Product Change Notification (PCN)

PCN #: 80-2021

DATE: 8/27/2021

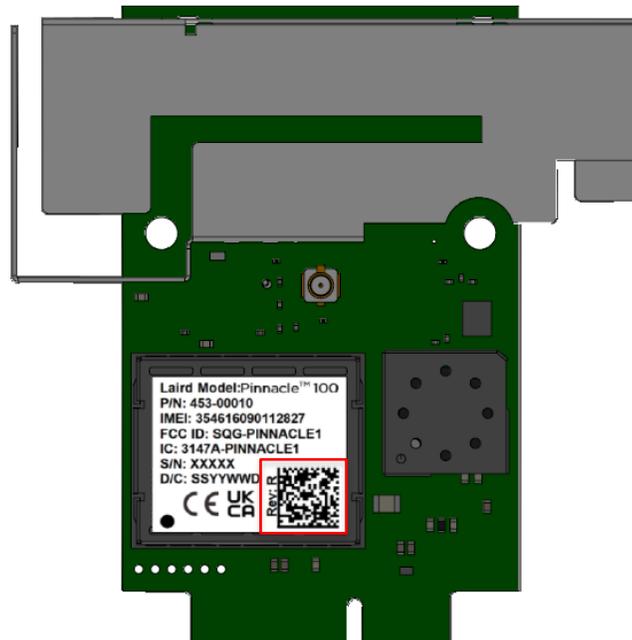
- Added UKCA certification logo to Pinnacle 100 modem module label.
- Added UKCA certification logo to back of MG100 gateway label.

- To ensure compliance with latest UKCA certification standards
- GA4.5 FW update for MG100 Gateway & Pinnacle 100 Dev Kits

5.3 Top Level Part Number Changes (Packaged Kits)

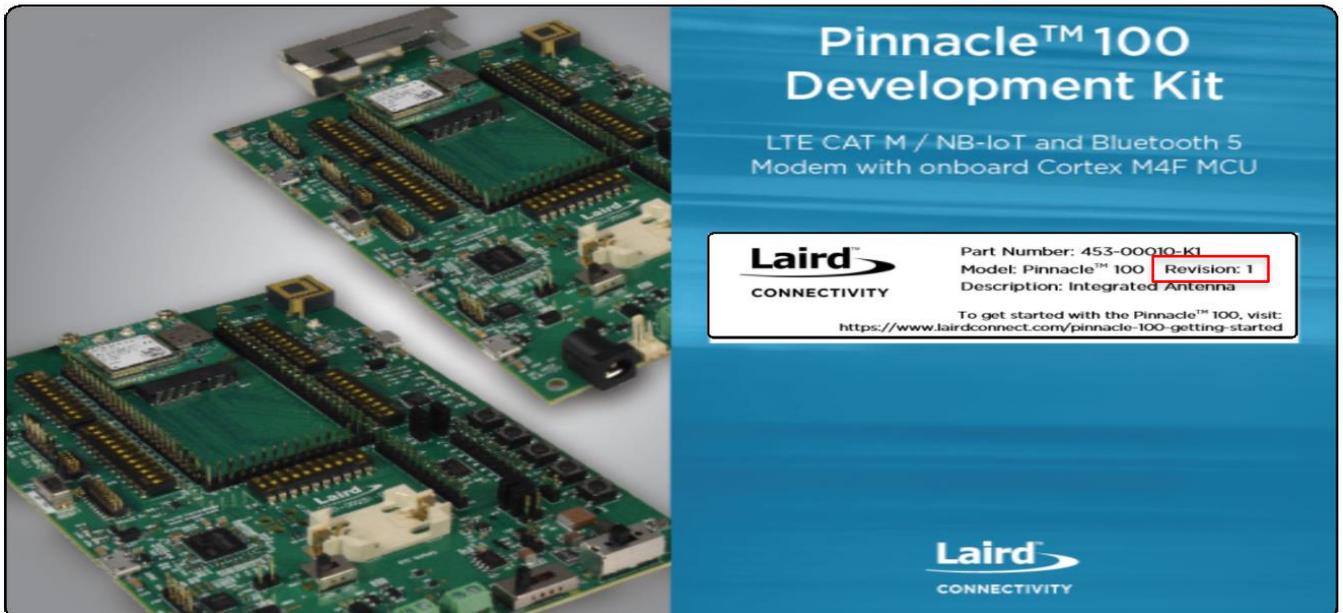
- The product revision level is defined as a revision number printed on the content label for all kits. The specific kit part number and revision can be found on the label within red square area, as highlighted below.
